**CITY OF HANOVER  
PLANNING COMMISSION MEETING  
JULY 27, 2020  
AGENDA  
VIA ZOOM (VIRTUAL MEETING)**

**SUBJECT:** **River's Edge of Hanover** for Concept Plan

**Re:** *River's Edge of Hanover Concept Plan Review*

**Re:** *Hilltop Renovation Plan Submittal Review  
WSB Project No. 016500-000*

PROJECT NUMBER: C20-0001  
**SHEET: C2**  
**GRADING PLAN**

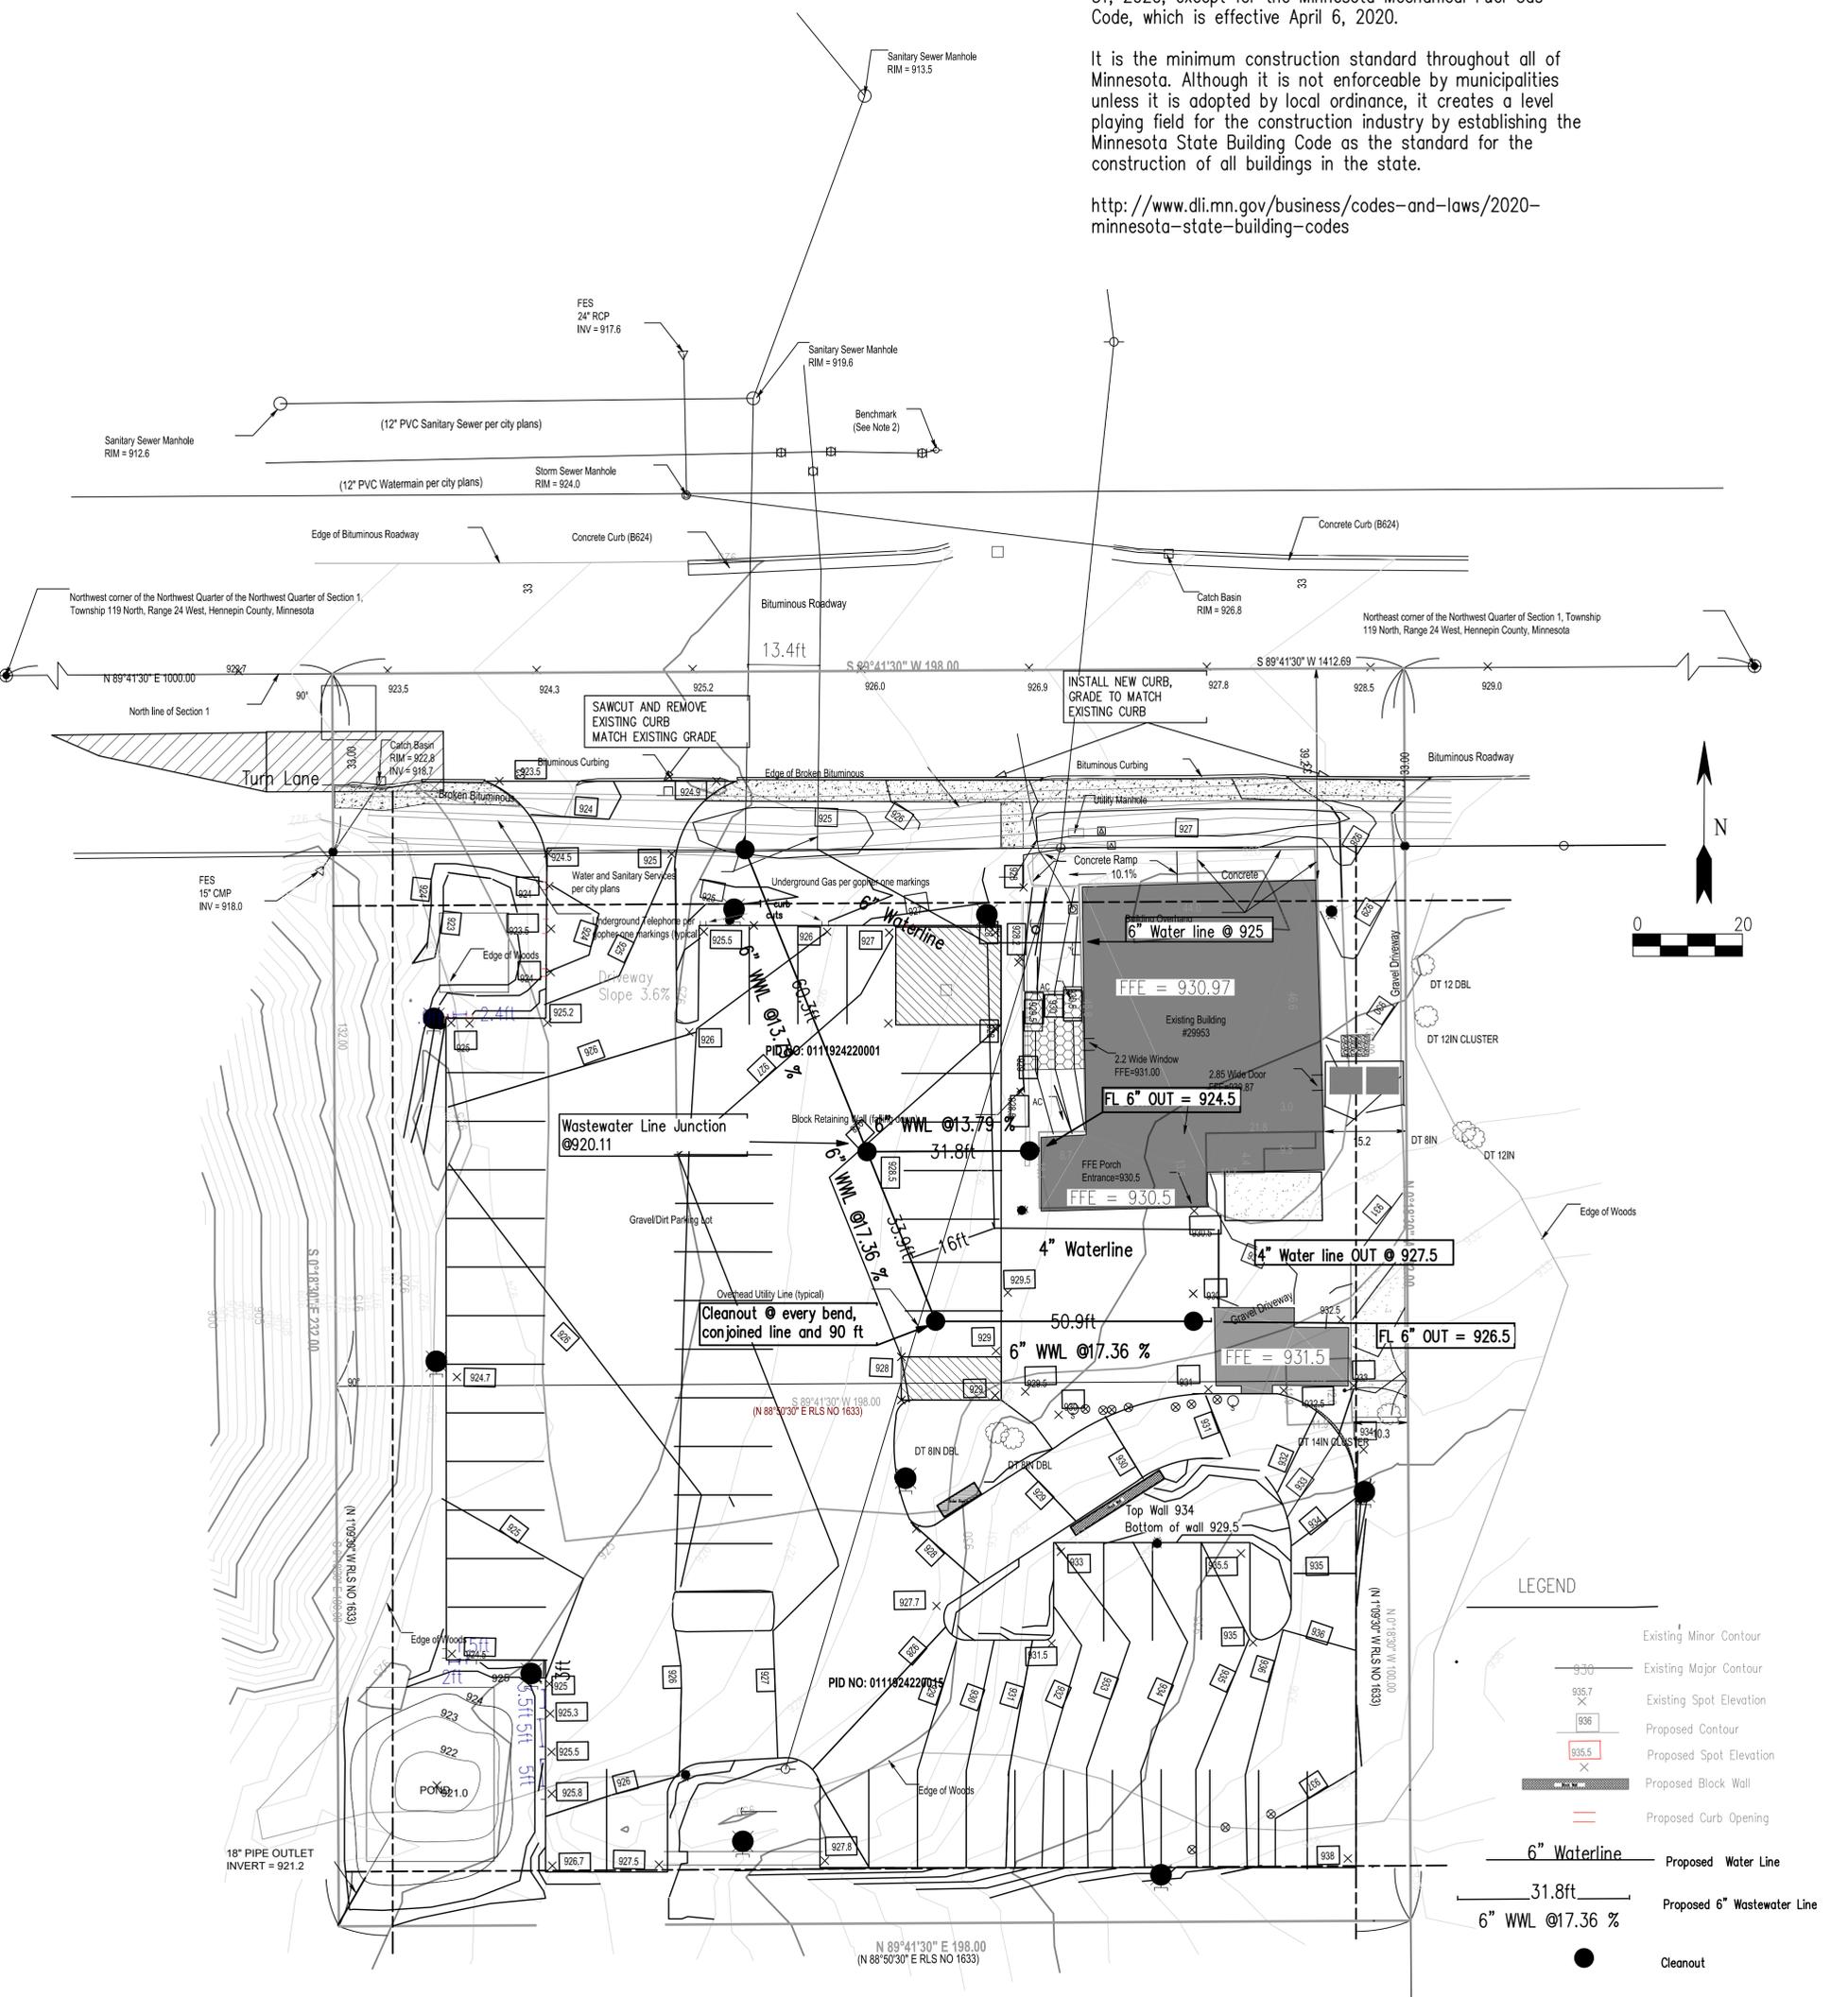
1. Show the proposed sidewalk along CSAH 19 on the grading plan.
2. The 925' contour east of the proposed driveway entrance is shown to hold water. Regrade or propose installing a culvert under the driveway discharging to the southwest of the driveway entrance.
3. The proposed retaining wall within the drive thru exceeds 4' in height and requires separate engineering design and calculations signed by a licensed professional engineer.
4. Drive aisle slopes should not exceed 10%. The proposed slope within the drive aisle along the southerly property line is in excess of 14%. During inclement weather this slope could become dangerous and difficult to travel.
5. Provide additional detail for how drainage will continue to the north behind the dumpsters. Curb appears to be shown that will impede the flow of drainage in this area. Is a curb cut planned for this area?

PROJECT NUMBER: C20-0001  
**SHEET: C3**  
**UTILITY PLAN**

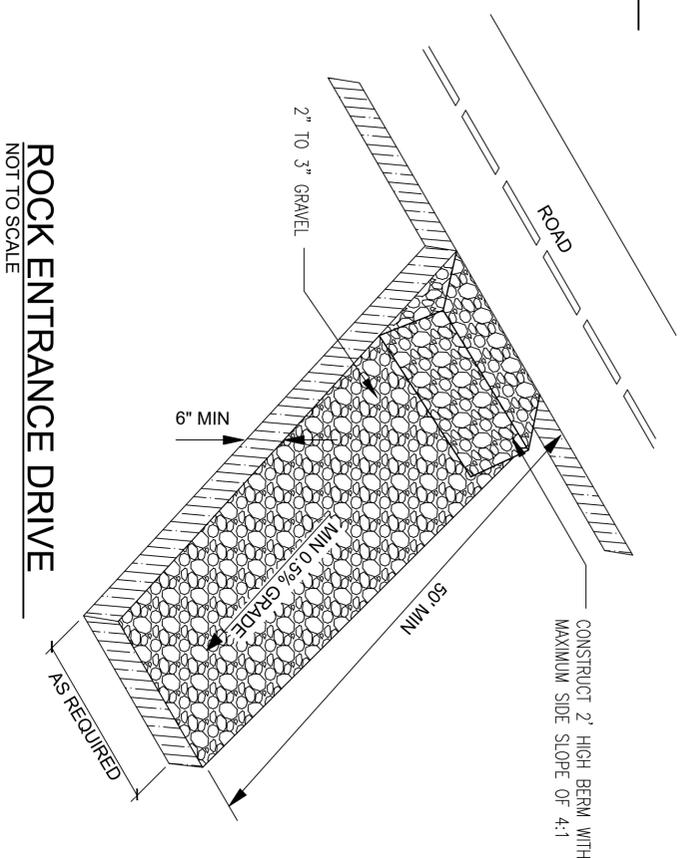
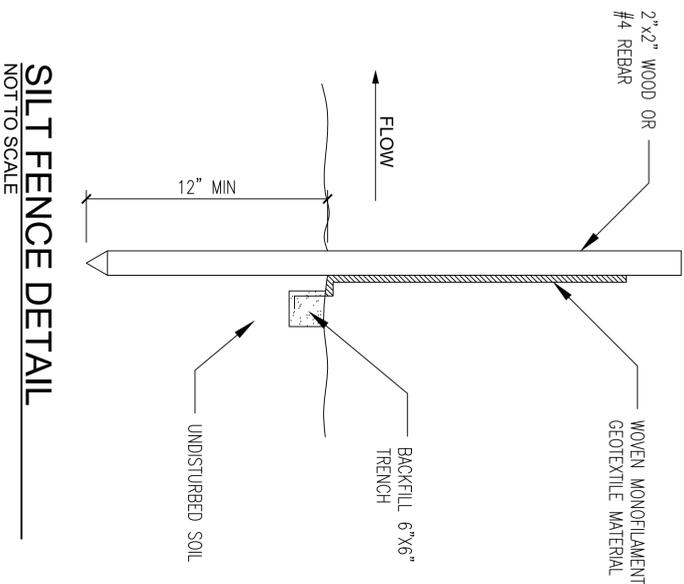
6. Specify the proposed material type for the water service pipe.
7. Specify the proposed material type for the sanitary service pipe.
8. Show a 6" gate valve at the point of connection with the existing water service.

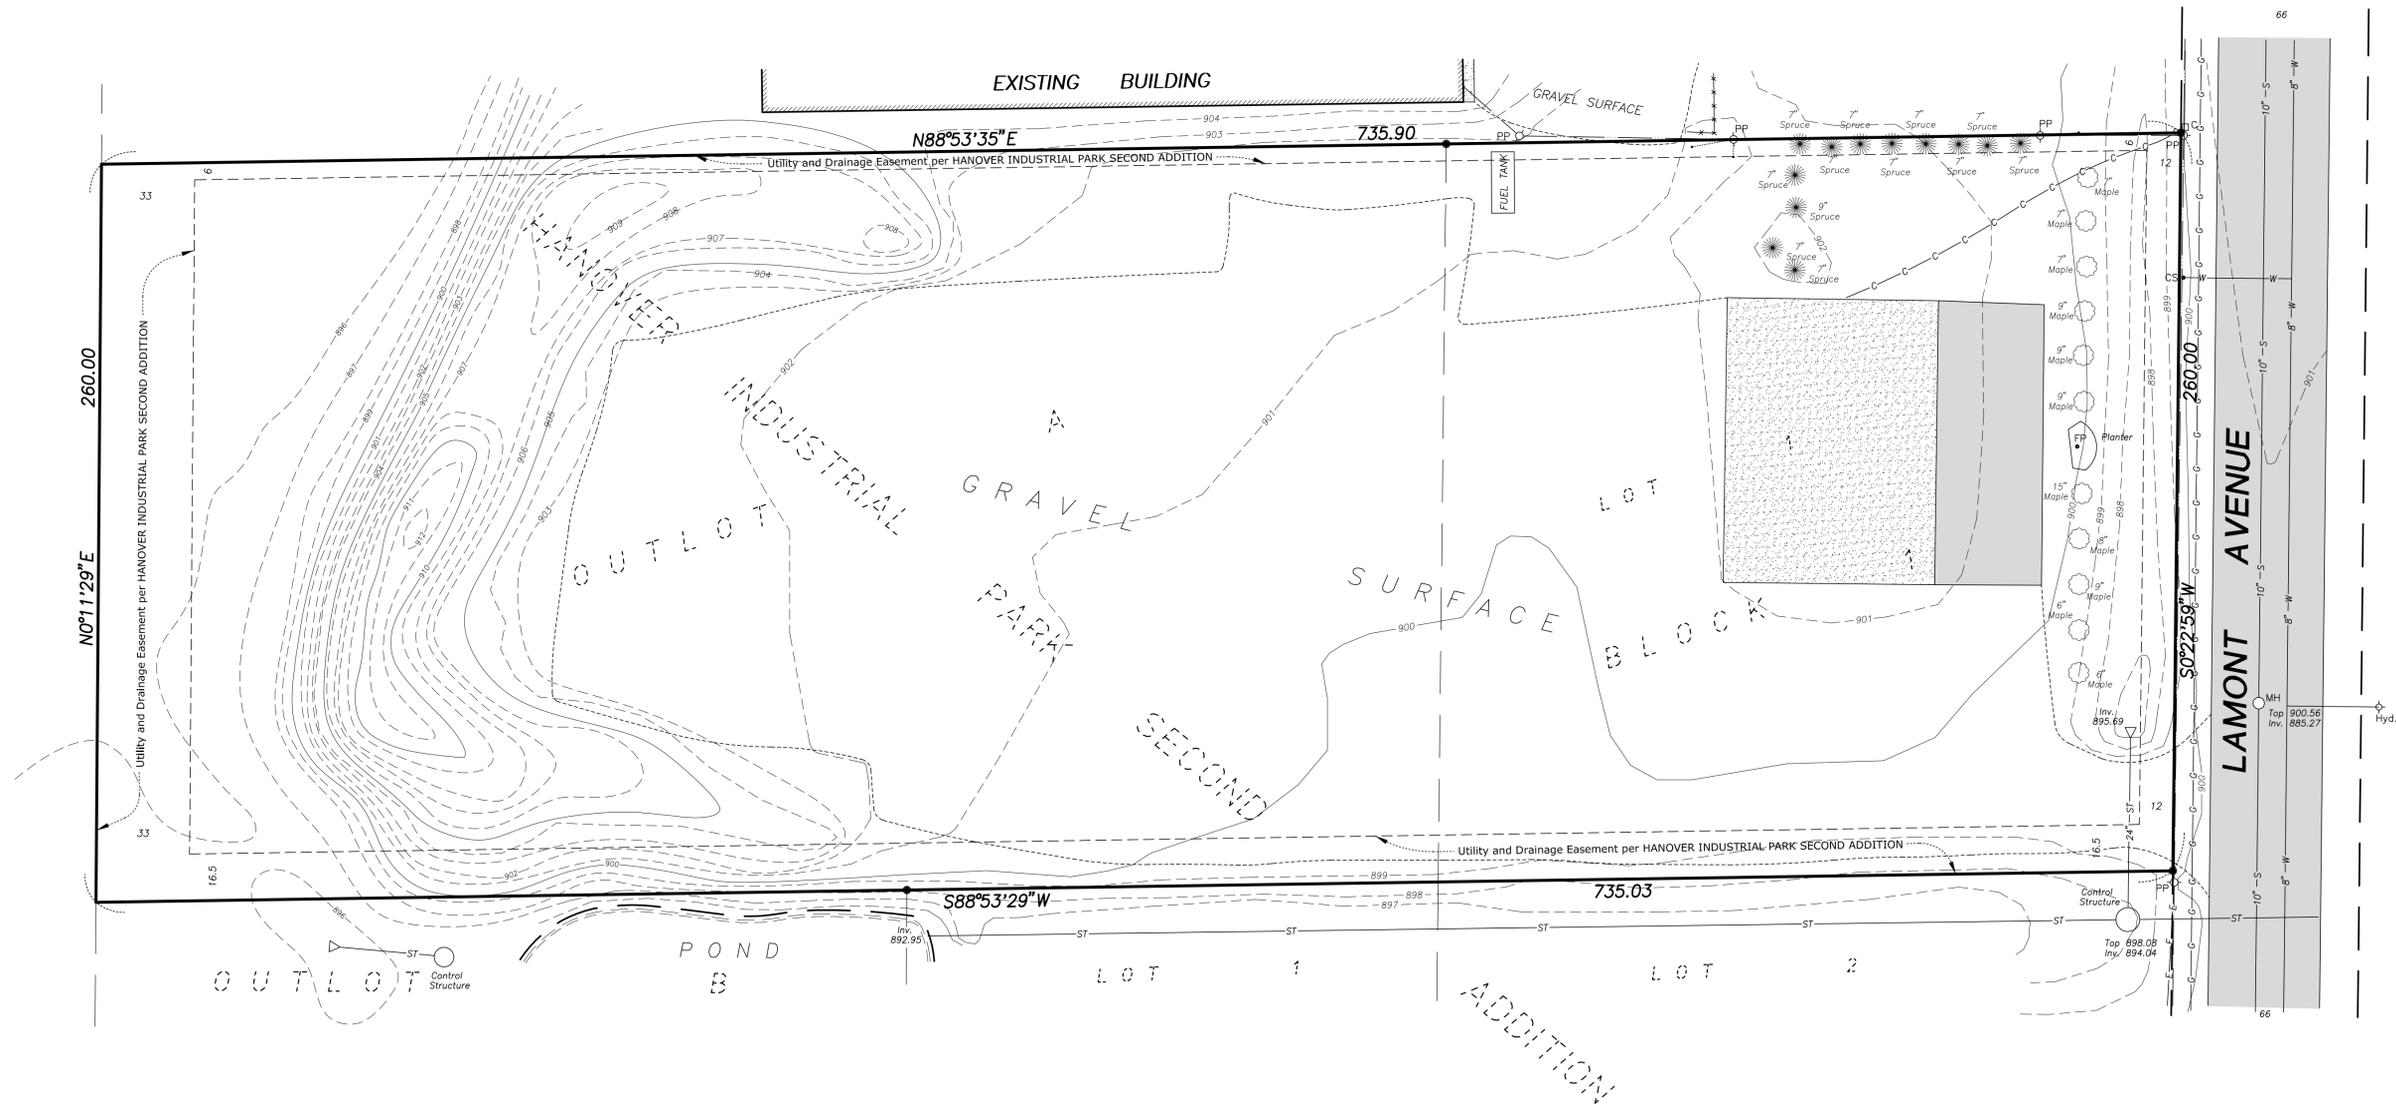
Due to the site not meeting ordinance requirements related to wetland buffers, it is recommended that the applicant improve the protection of the wetland.

1. Show a wetland buffer 30 feet from the wetland that will be seeded in a vegetation mix to be approved by the City Engineer. Wetland buffer signs shall be installed as per the City Engineers specs along the eastern edge of the wetland buffer. No outside storage or parking of vehicles to be permitted in the wetland buffer.
